GEK- 34217

Insert Booklet - GEI-31073

### RECLOSING BLOCKING AUXILIARY RELAY

0208A8419

FIG. 1 (0246A3664) Internal Connections For 0208A8419

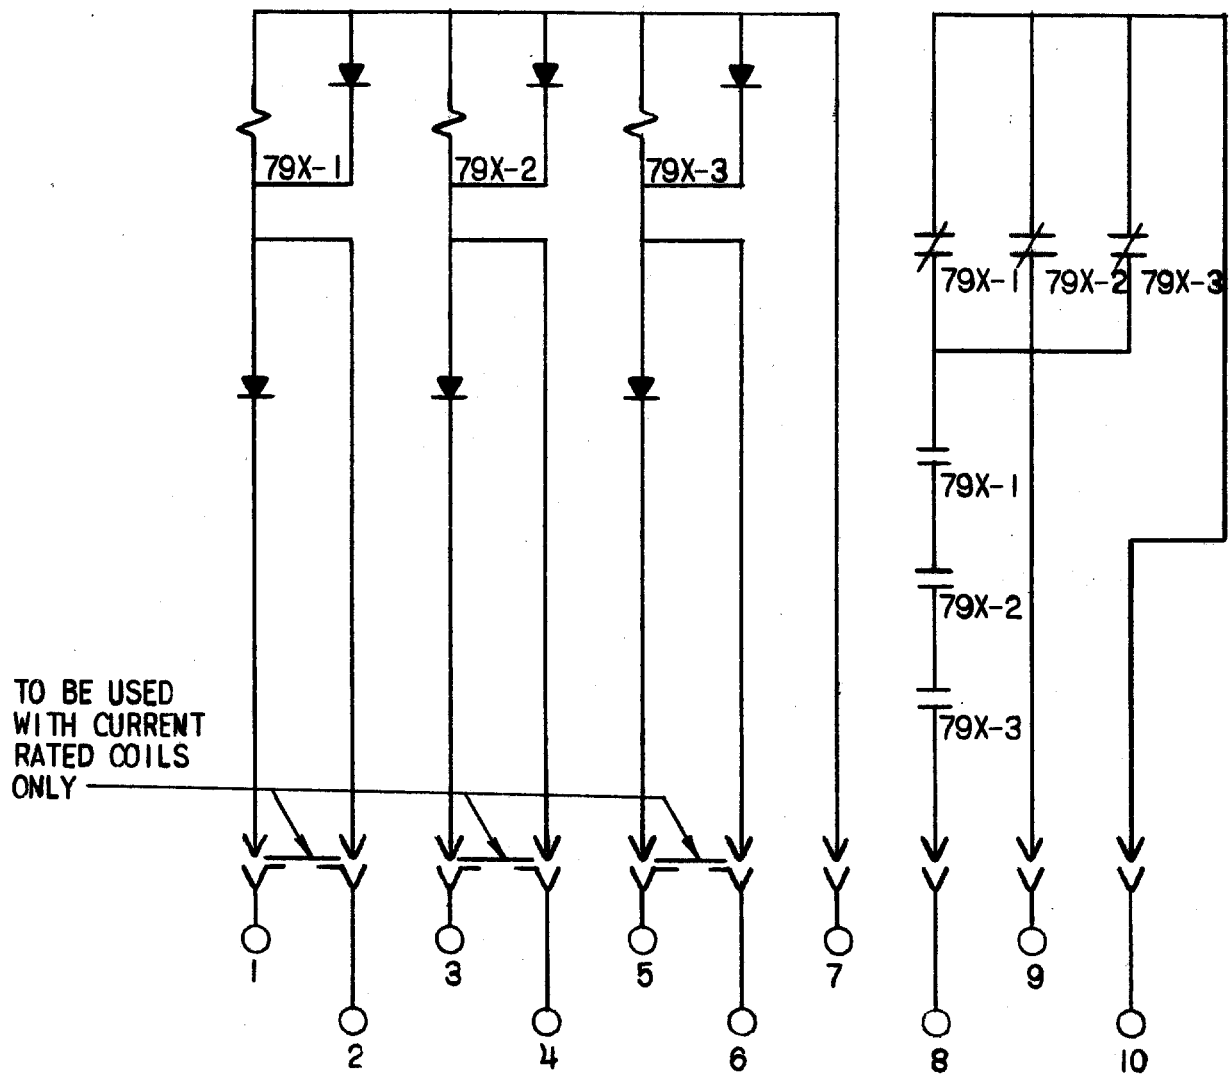
1. Relay unit 79Y is omitted.
2. Relay units 79X1, 79X2, and 79X3 will pick up in 8 milliseconds and drop out in 33 milliseconds or more.
3. The internal connections are as shown in figure 1 of this supplement.
4. The capacitors in parallel with the tripping diodes have been omitted at the request of the customer. This omission will decrease the relay's resistance to high voltage transients.
